1360 WALTON BOULEVARD PROPOSED STARBUCKS

Site Plan Review

Conditions and mark-ups noted throughout the plan set must be addressed prior to final approval.

CITY FILE #21-030 SECTION #9 SCALE: AS SHOWN PROJECT ID: DET-200412

SITE PLAN

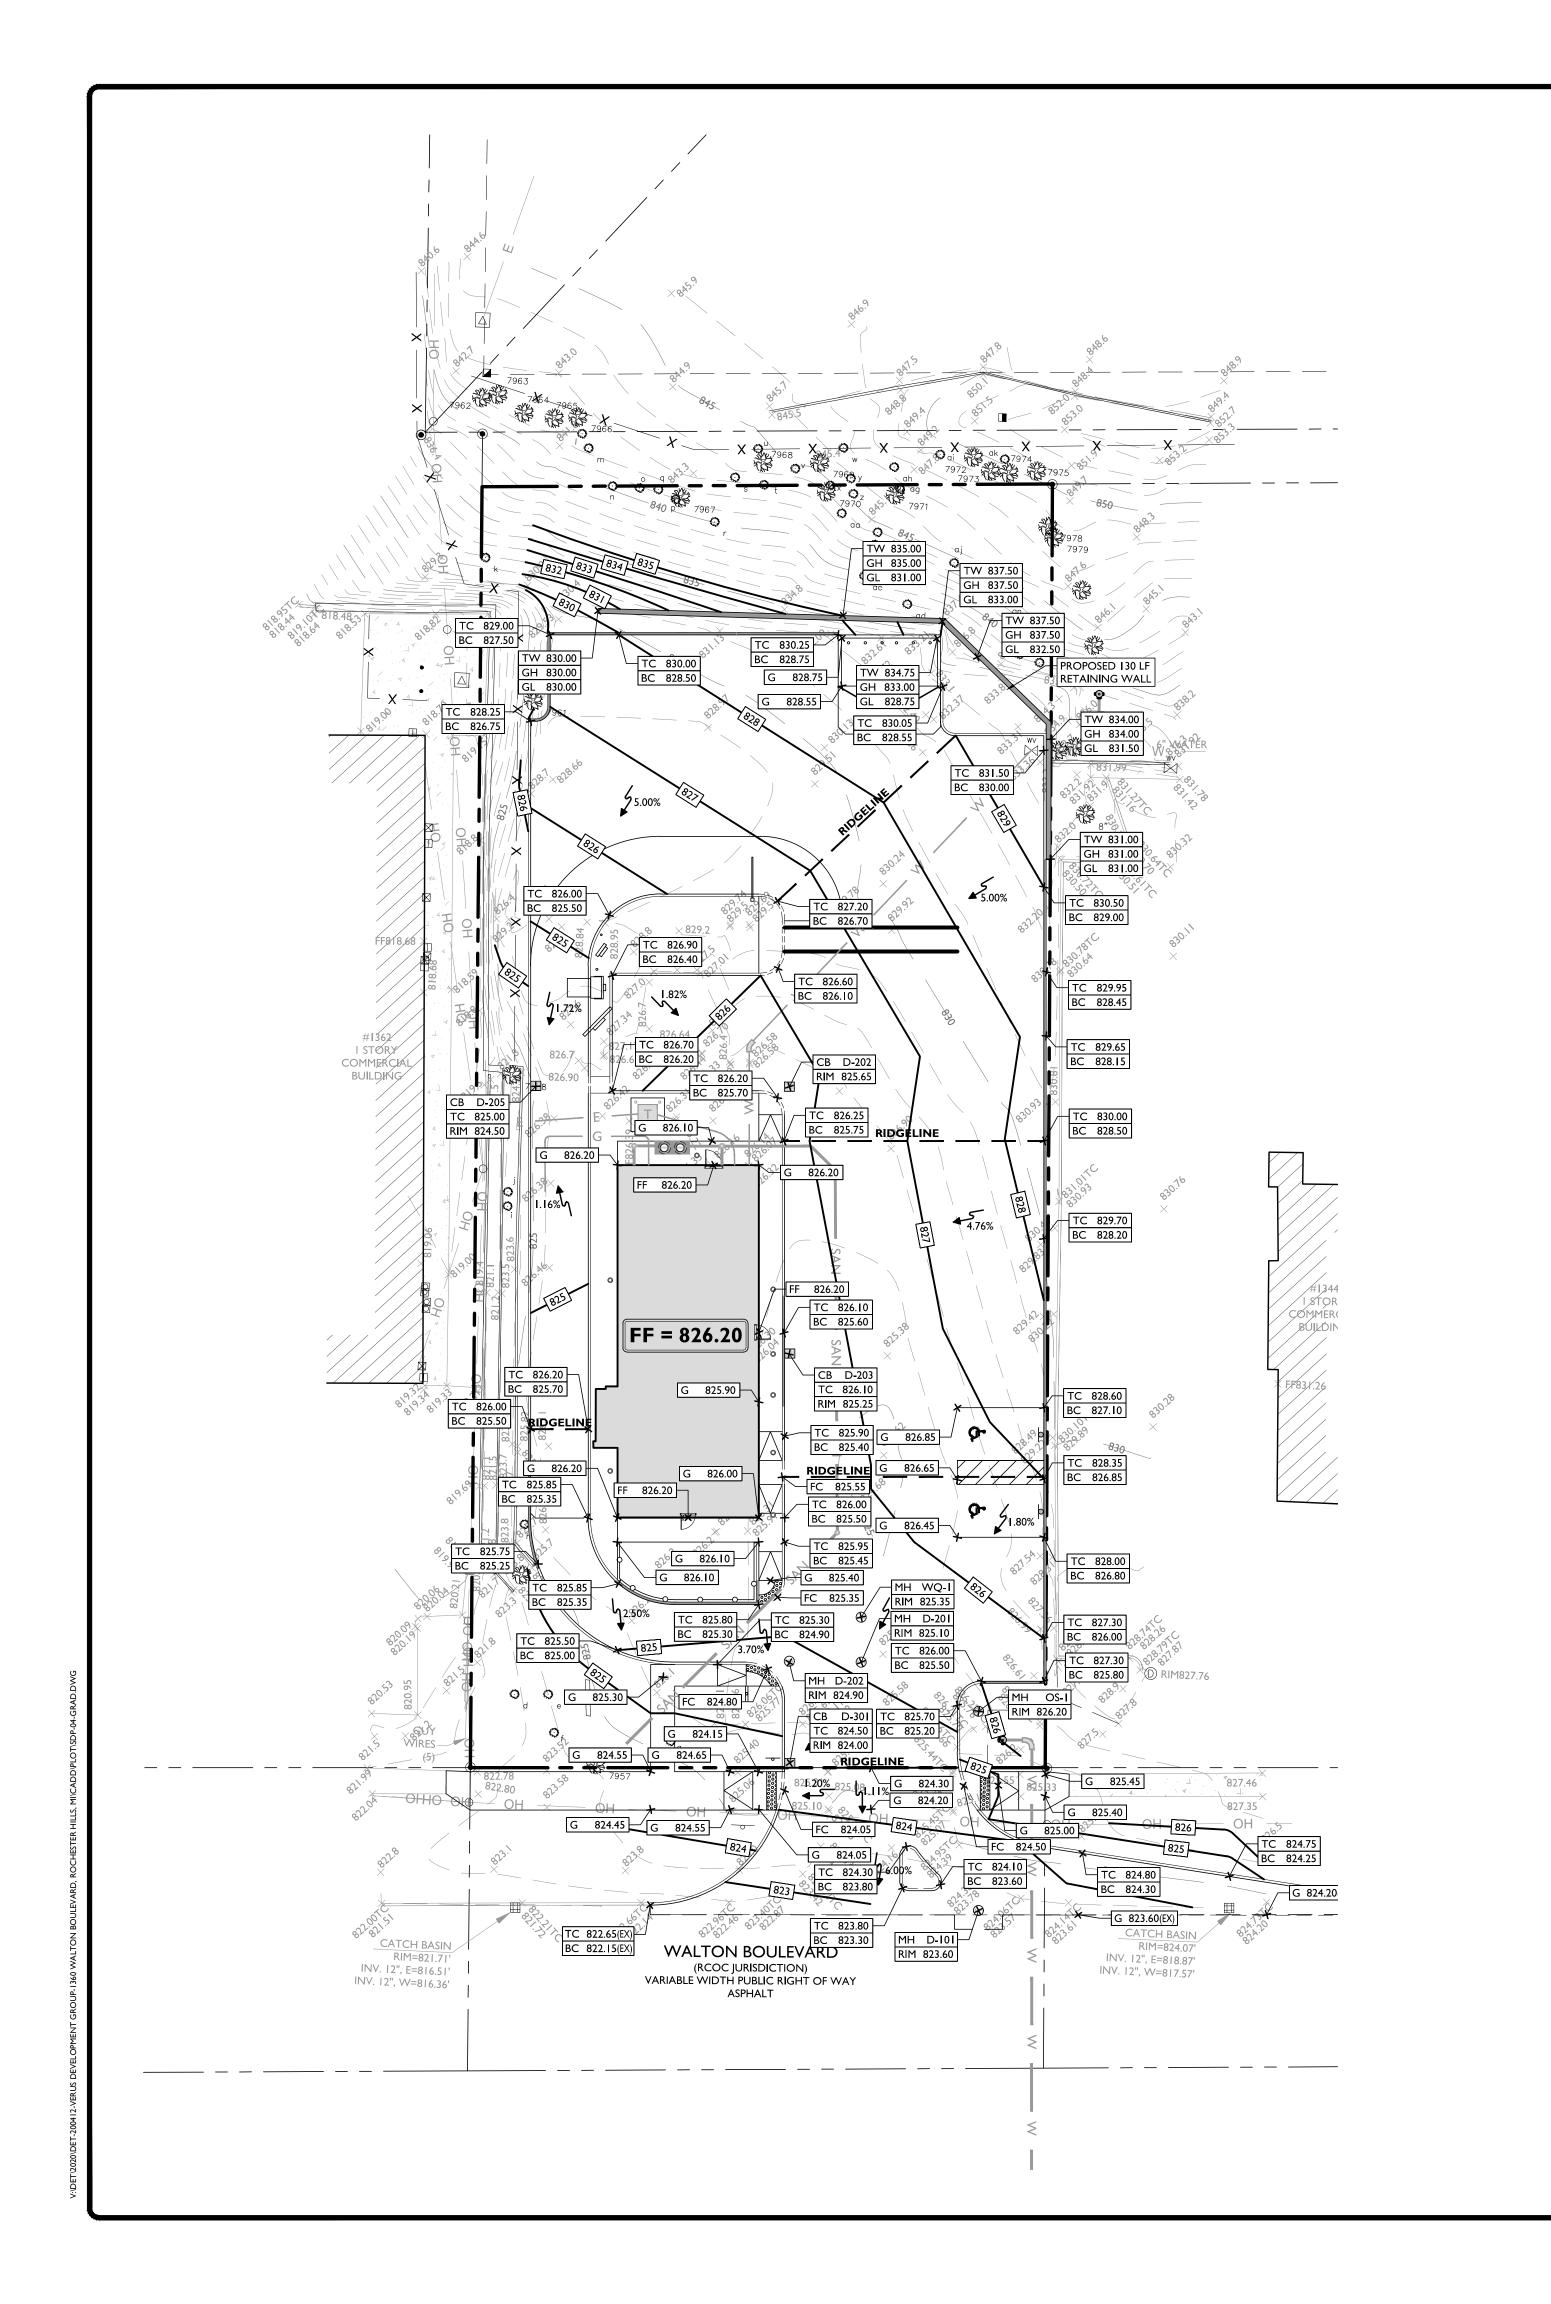
Rationale for full access drive option, the following would be the order of suggestions:

1. Do not permit this type of heavy drive thru use at this location.

-The site itself is very narrow and not deep, which is not ideal for a drive thru coffee shop.

Vehicles may pack up into Walton Blvd especially if they are not pulling up as far as they can into the drive thru/parking lot.

-The stacking length is relatively short and only exacerbated the more that drivers don't pull up as far as they can to the car in front of them due to being on cell phones and not paying attention. -The drive thru itself does not have a bypass lane so patrons parking to go inside will be competing with backing up vehicles when leaving the dining area.

2. Allow full access drive (assuming option 1 is not feasible)

Not ideal due to the high AM peak use that will be competing with AM school traffic at Rochester High School. -School and drive thru traffic will be competing for limited CLTL storage length and weaving in and out of the lane to get around staged vehicles.

3. EB Walton Blvd Traffic restricted with NO Lefts into the Driveway Approach

-The compliance rate for EB motorists to adhere to the NO Left turn to enter the site could be low. -Would probably need a very low profile curb & gutter raised island to allow emergency vehicles easy access in and out of the site, which makes it more enticing to simply drive over it.

-Maintaining a high compliance rate will only be as good as OCSO ability to provide the necessary resources for adequate enforcement.

This would be the only commercial site in the City that we know of with a single drive approach to have turn movement restrictions. All the others have multiple access points.

This may place an undue burden on Wendy's. Drivers that do comply with the turning restriction will most likely just head EB on Walton Blvd and

turn into Wendys only to do a U-Turn to then head back west onto Walton Blvd to get to Starbucks.

Drivers that are coming from the east are unlikely to drive head east past the dual lane x-over at Livernois Rd to then head back west onto Walton Blvd. -Keep in mind that this site only has 1 access entrance where the other locations with the pork-chops islands have multiple options for ingress/egress
